ADDENDUM # 1

DATE: September 26, 2011
TO: All Prospective Proposers
SUBJECT: **Request for Proposal # 111065**
Siren Control and Warning System Improvements

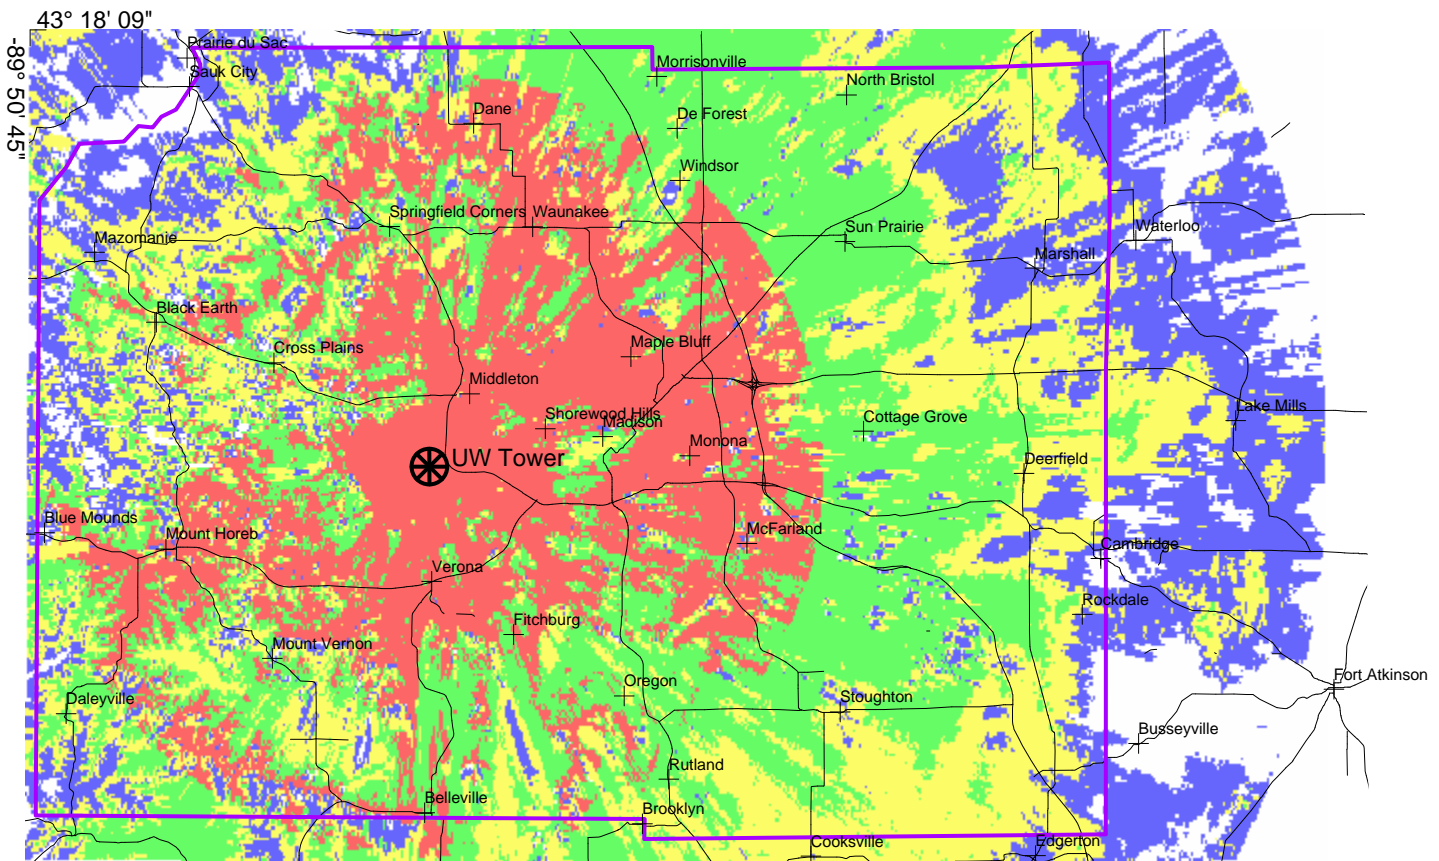
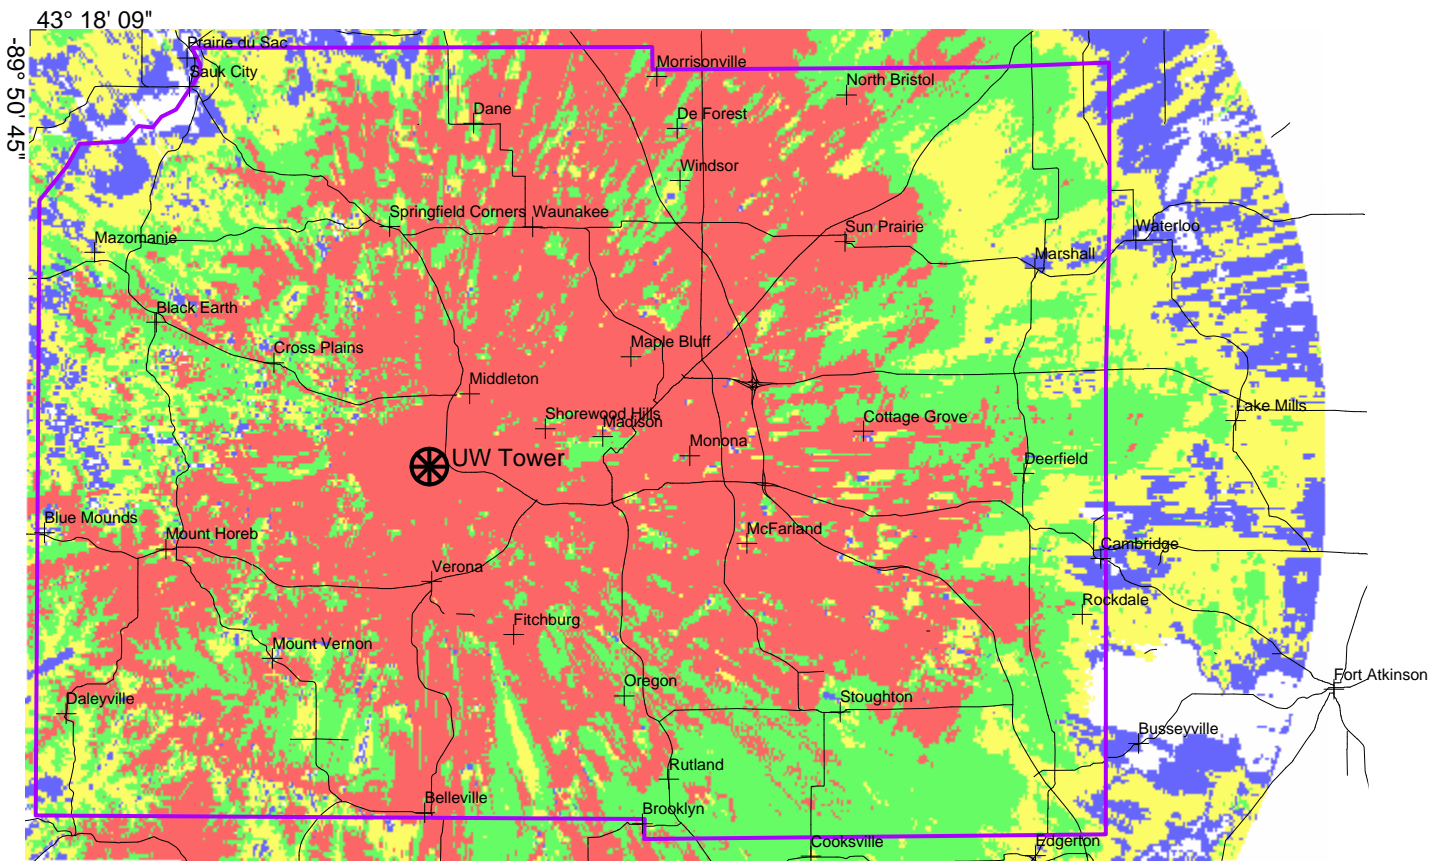
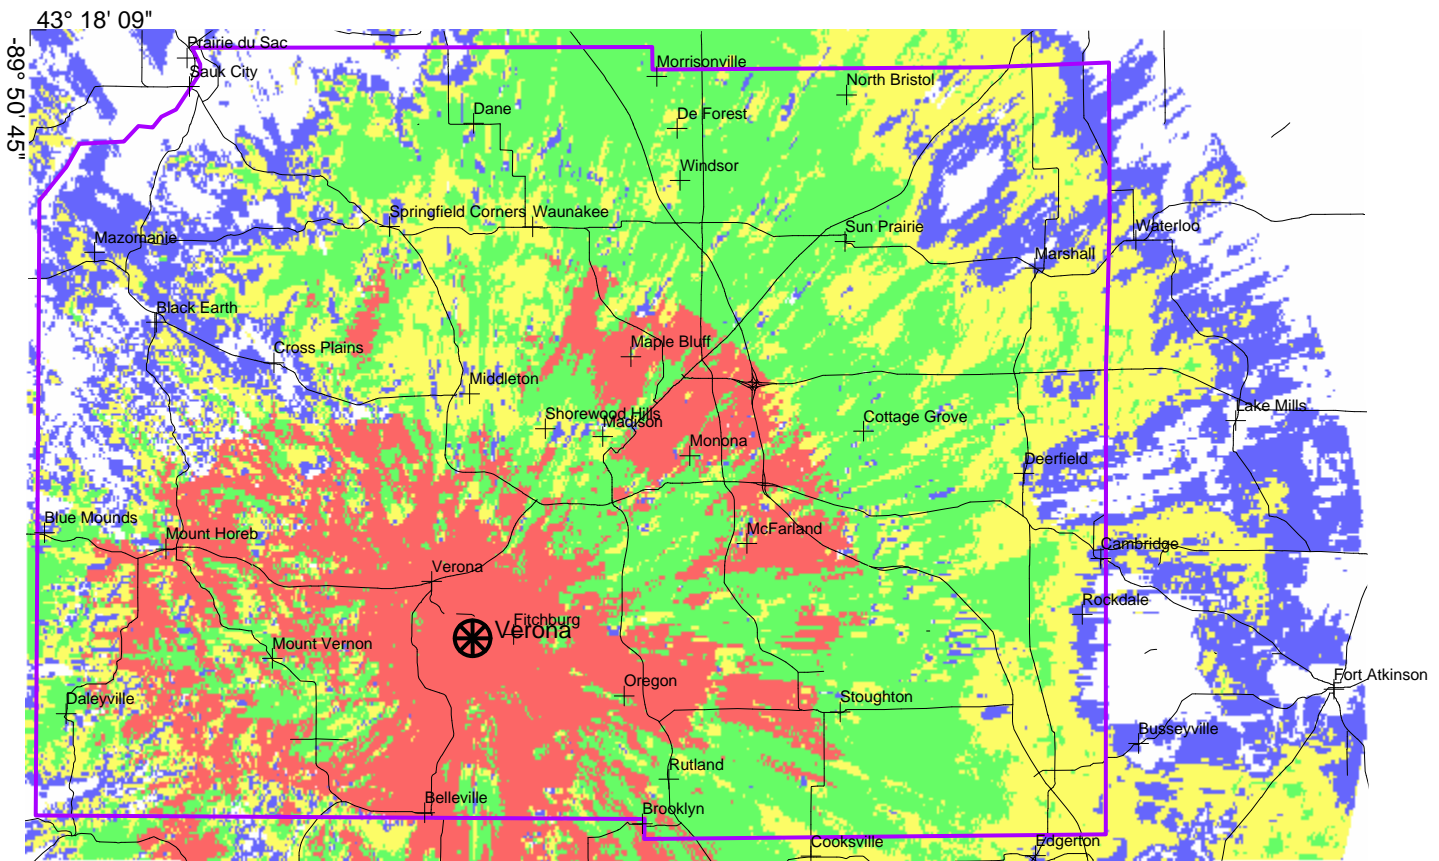
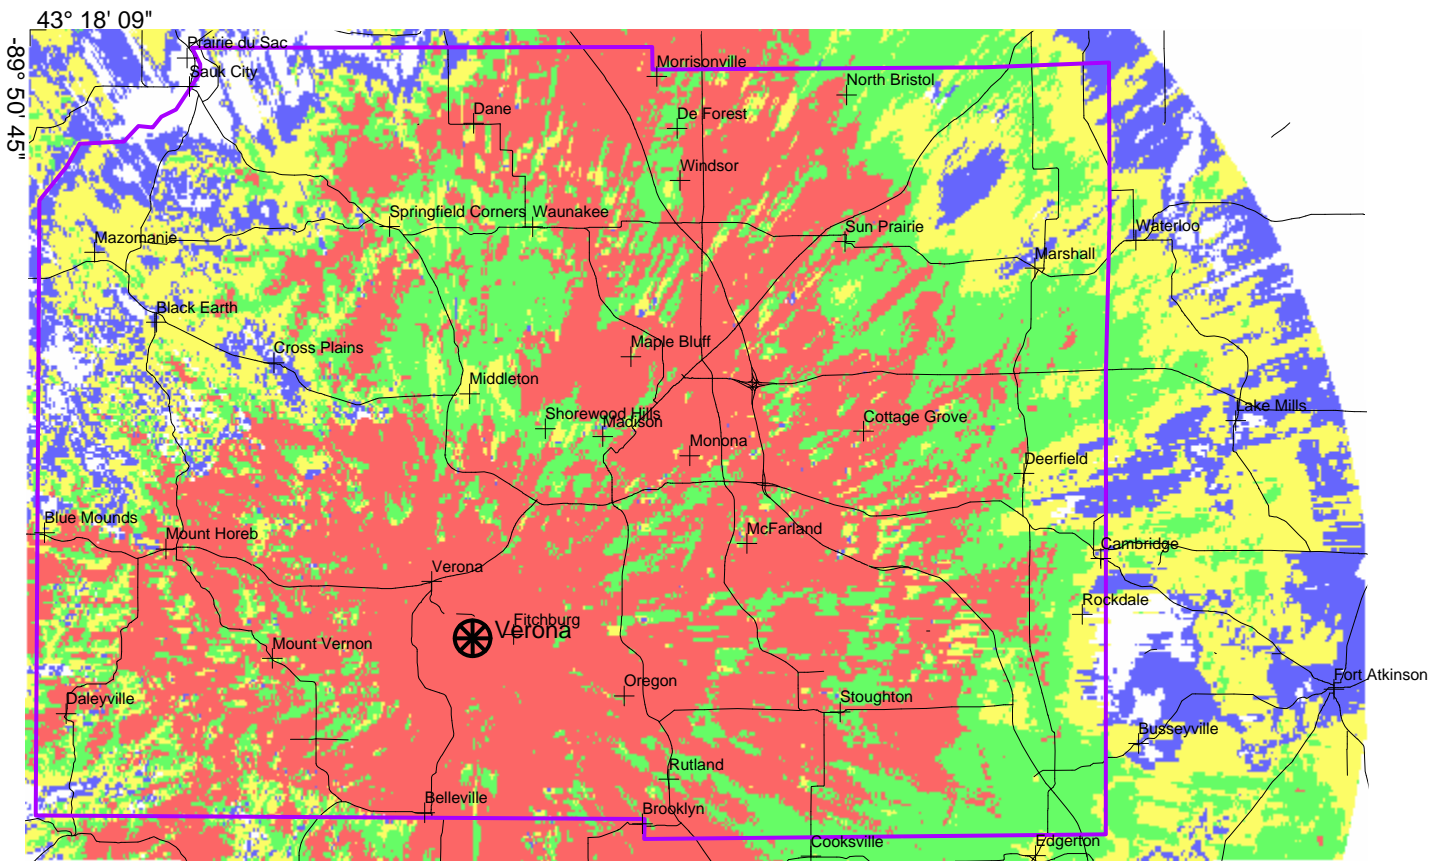
- **Will the new frequency be dedicated to the siren system?** Yes
- **Who is responsible for Radio Propagation? Has there been a propagation study/coverage map produced?** Radio propagation was studied as part of the DaneCom system with the primary site being at the UW tower and the secondary site at the Verona tower based on using 3.0 dB antennas at 20 feet and 25 watt radios. The propagation maps are attached below.
